Access Compliance Report

Public Rights-of-Way

(Pedestrian Signals)

Intersection ID: N/A	Main Street:	Cross Street: N/A	Location: N/A
ADA ID: E2224E1D2534	Signal Type: One Push Button-APS	Overall Compliance: No	Severity Score: BTN 1: N/A BTN 2: N/A No BTN: N/A
Codes/Mitigation Info/Possible Solution		Field Measurements/Component Compliance

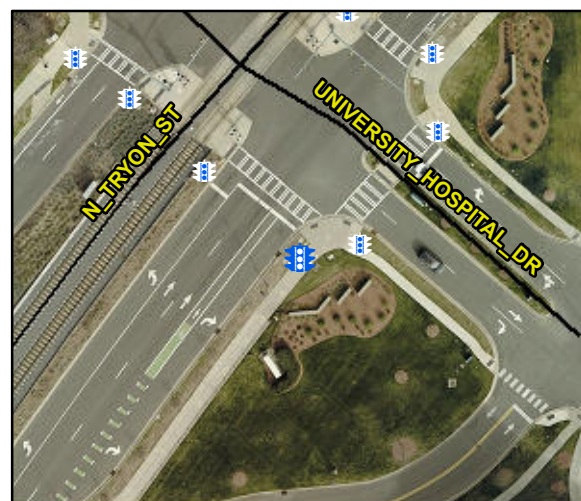
PROW/ADA: R404.2, R404.3, R404.7.2,
R209.1, MUTCD 4e.10

Possible Solutions: Remove & Replace
Replace APS Button With New APS Button.
Remove and Replace Clear Space.
